E3620A-06-S

S E R V I C E N O T E

E3620A Lab Bench DC Power Supply

POSSIBLE SHOCK HAZARD

3**REMOVE COVER**

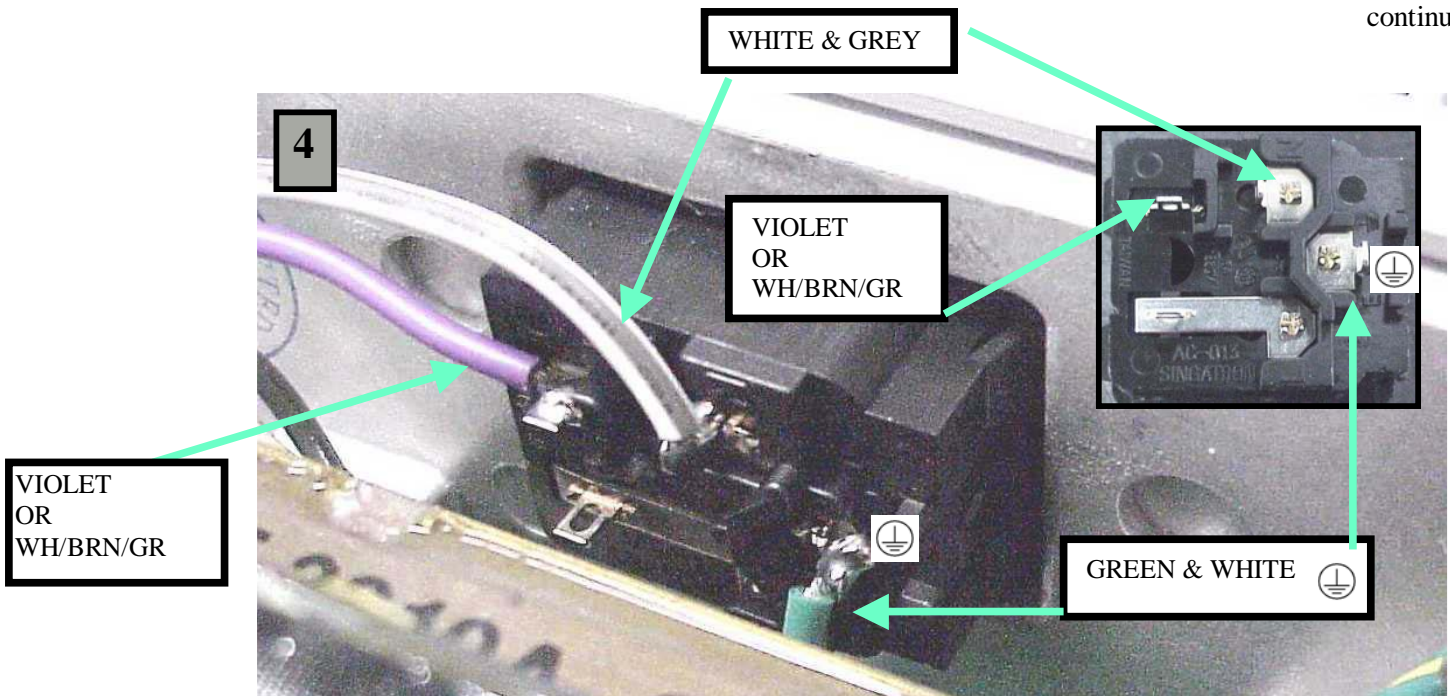
Pry Rear Bezel and Front Panel away from Cover in four places. Then lift Cover off unit.

Pry Tabs out on rear of Top Cover and lift Cover off of the unit
